## **Town of Westwood**

re: #790 Gay Street - DEP file # 338-0725 - Minor Modification - Assessors Map 16, Lots 005 and 437

Subject: Summary of Modifications to site plan

Project Name: Hanlon-Deerfield Elementary School Project

SKETCH-1. Remove portion of STEM porch pavement and site wall

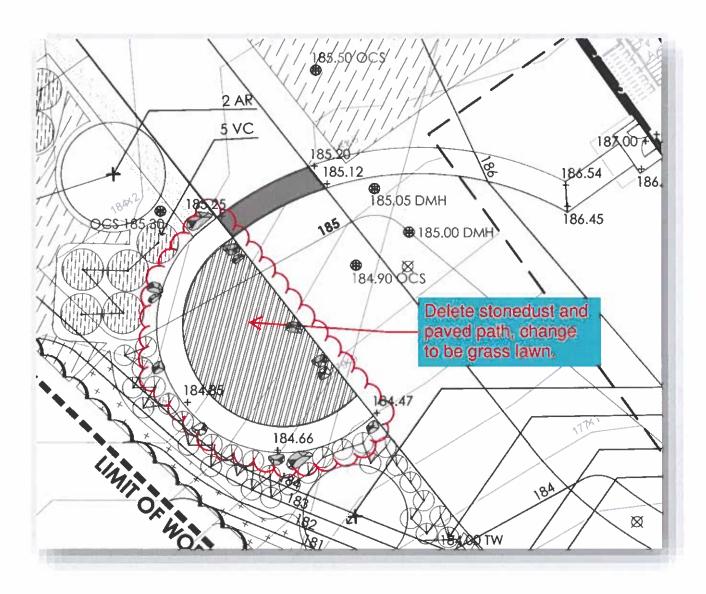
- 1. A portion of the STEM porch, located outside the library, art and music rooms is scaled down in size, and paving associated with the outdoor classroom area, converting approximately 1,000 sf of concrete and bituminous pavement and stone wall to lawn/grass. This has resulted in a reduction in several stormwater drainage systems accordingly. Please see attached, 13759 Stormwater memo, prepared by Nitsch Engineering, outlining these revisions. The central portion of the STEM porch concrete patio area directly outside the library will remain, along with the canopy. Refer to the attached "2-VE Revsns..." document.

Sketch 2: Outdoor Classroom: Delete stonedust and paved path, change to grass lawn

Sketch 3: Walkway Canopy becomes an Alternate

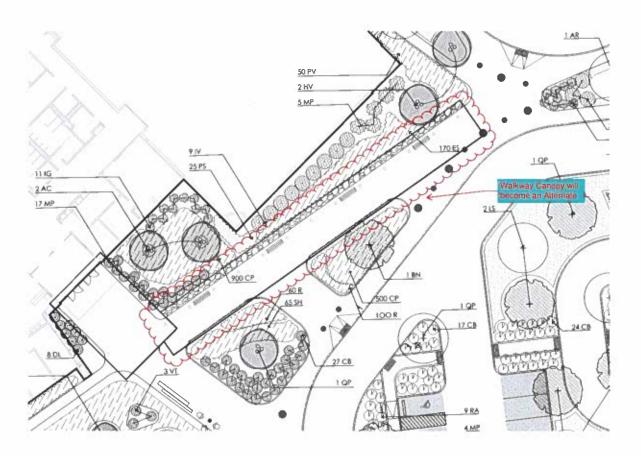
- 2. The walkway canopy will be placed as an Alternate. Should bids come in favorably, the school district would accept this Alternate. Refer to the attached "2-VE Revsns..." document
